BARANGAROO SOUTH
C1 BUILDING - BASEMENT EXIT INTERSECTION WORKS

This letter has been prepared in response to a Road Safety Audit (RSA) report prepared for proposed intersection modifications at the basement exit at Hickson Road, Sussex Street and Napoleon Street, Barangaroo.

Detailed design road safety audit

CARD-PROJ-0003-08 DD RSA HICKSON-NAPOLEON REV 1

Figure 1-2 View of basement exit ramp (facing south) approaching the signalised intersection

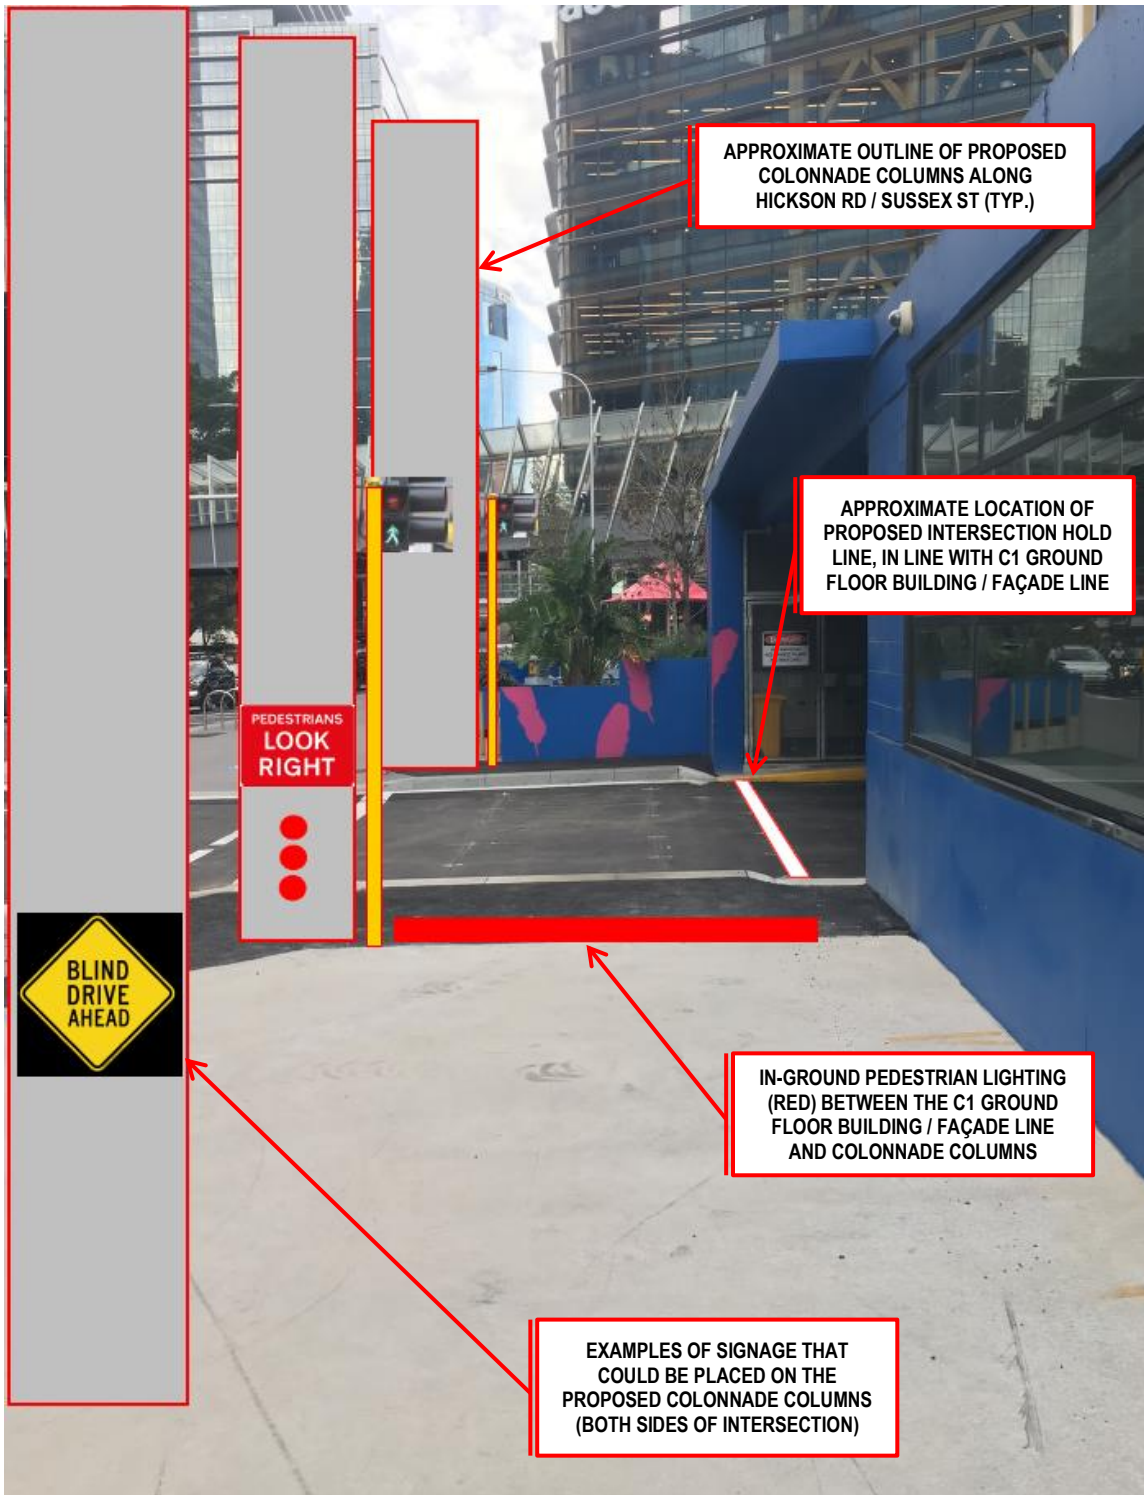
- A. Placement of a dynamic flashing light on the wall adjacent to one or both of the basement exit lanes, which is linked to the red signal at the intersection, refer to **Figure 1-2**.

Figure 1-4 View of future footpath under proposed colonnade (facing south)

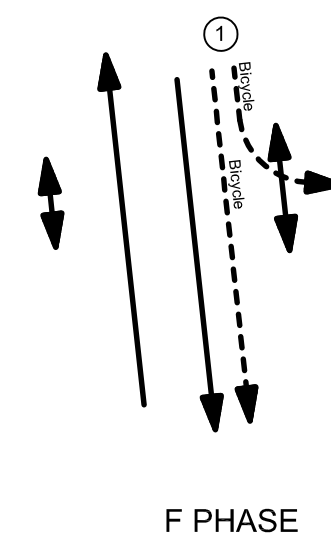
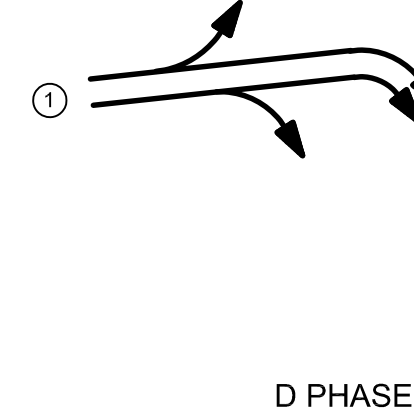
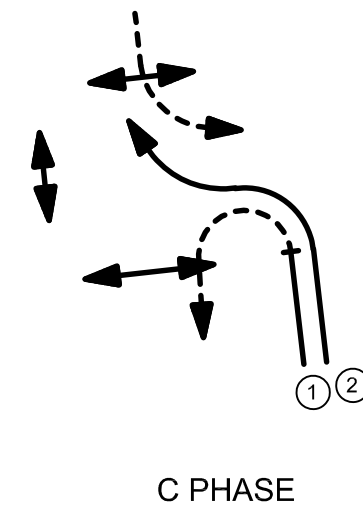
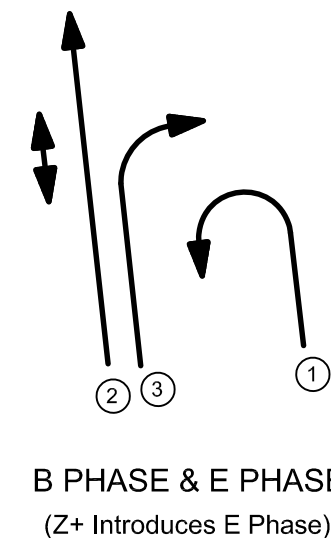
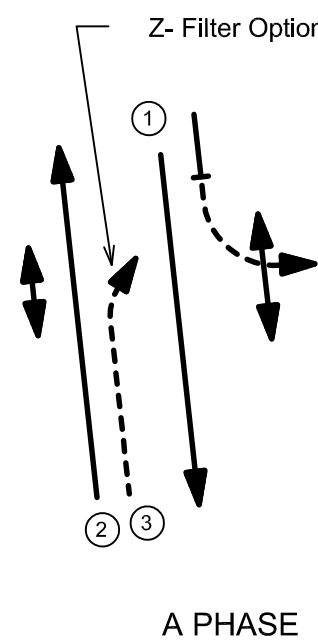
- C. Provision of warning signage on the proposed colonnade columns to alert pedestrians to vehicles exiting the basement car park. Examples of such signage are presented in **Figure 1-4**.

TCS No 4625

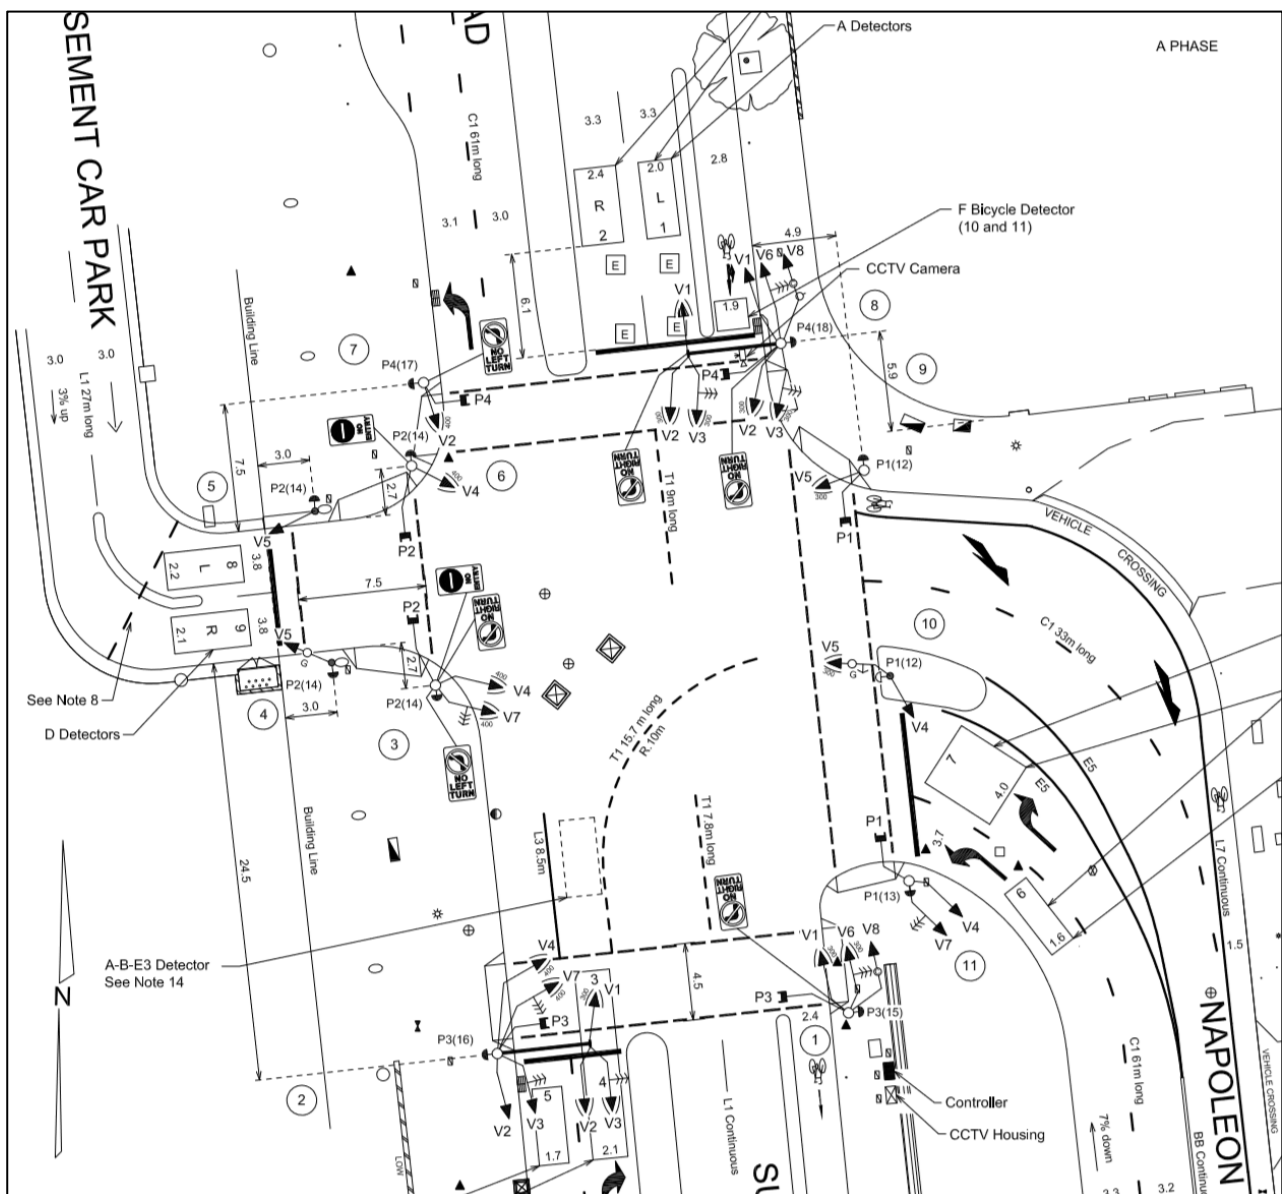
- > Traffic Signal Design Plan (TCS 4625, Sheet 4), prepared by Road Delay Solutions. First issued on 14th March 2018, then updated subsequent to receipt of RSA report and reissued 19th March 2018 (contained as **Enclosure 1**).
- > Detailed design Road Safety Audit report, prepared by DC Traffic Engineering and dated 15th March 2018 (contained as **Enclosure 2**).

4	C phase on TCS Plan – conflict between left turn movement for cyclists and pedestrian crossing	F
5	Signal Posts	This has been addressed in the revised Traffic Signal Plan dated 19 th March 2018.
6	Egress driveway from building car park	G
7	Primary and dual primary signals in building car park egress lane	H
8	Use of signals and signs	To be considered further during detailed design
9	Pavement loop detectors	To be considered further during detailed design, in light of existing and proposed utility services that may conflict with the location of the loop detectors.

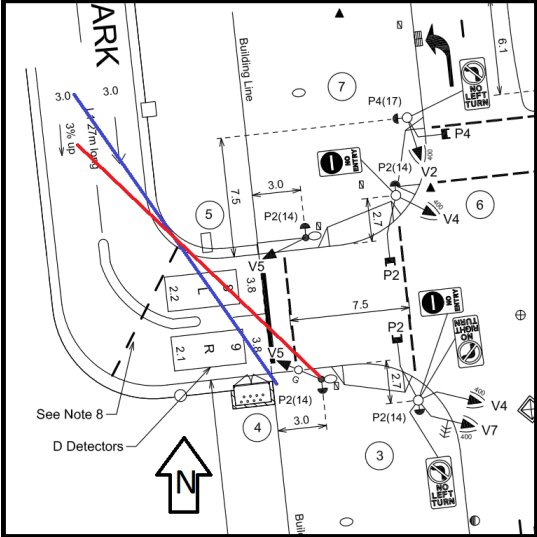
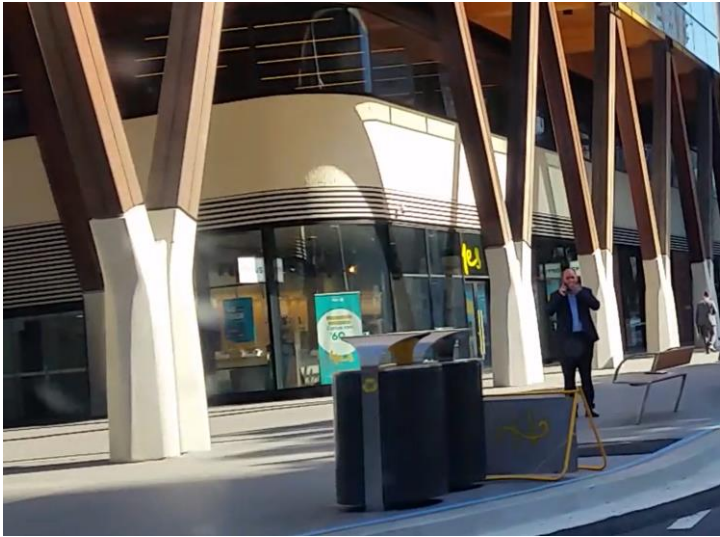
Ref	Location	Road safety audit finding	Priority
4	C phase on the TCS plan.	The C phase (see image below) includes a southbound left-turn movement from Hickson Road to Napoleon Street for cyclists. This movement (circled in blue) is marked as a filtered movement. However, it is filtering through the P4 pedestrian movement on the northern leg of the intersection. This is a direct conflict between the cyclist and pedestrian and could increase the risk of <i>bicycle-pedestrian</i> crashes. Typically, turning movements should not filter through conflicting movements on the approach side of the intersection. Rather, they would filter through parallel traffic/ pedestrian streams on the departure end of the manoeuvre. That is, if this was a filtered left-turn movement, then the movement being filtered through would be the P1 north-south pedestrian movement across the Napoleon Street leg.  Above: The C phase in the TCS plan indicates that southbound left-turning cyclists will filter through the east-west pedestrian movement (P4). This is a direct conflict which should not allow filtered movements.	Medium

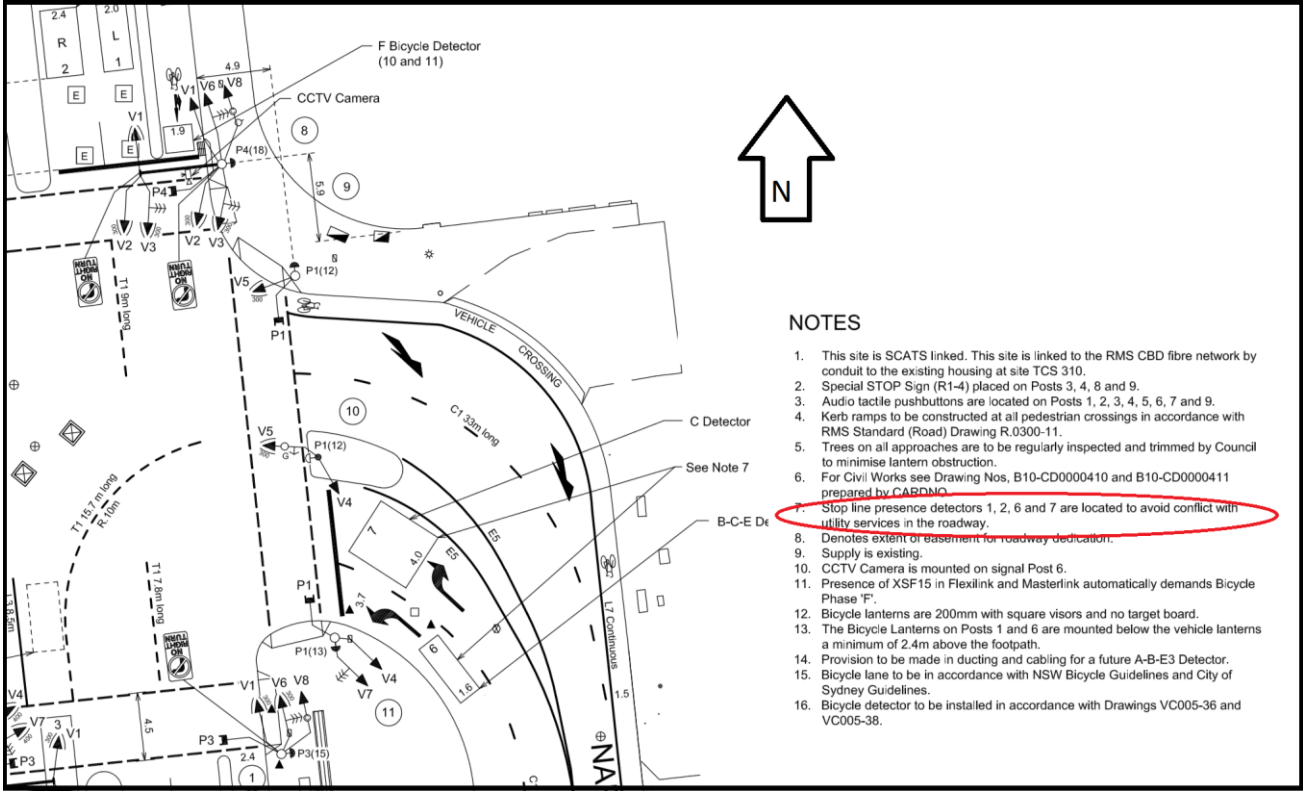
Above: Note 3 on the TCS plan fails to include posts 9 and 11 in the schedule of posts that require audio-tactile push buttons.
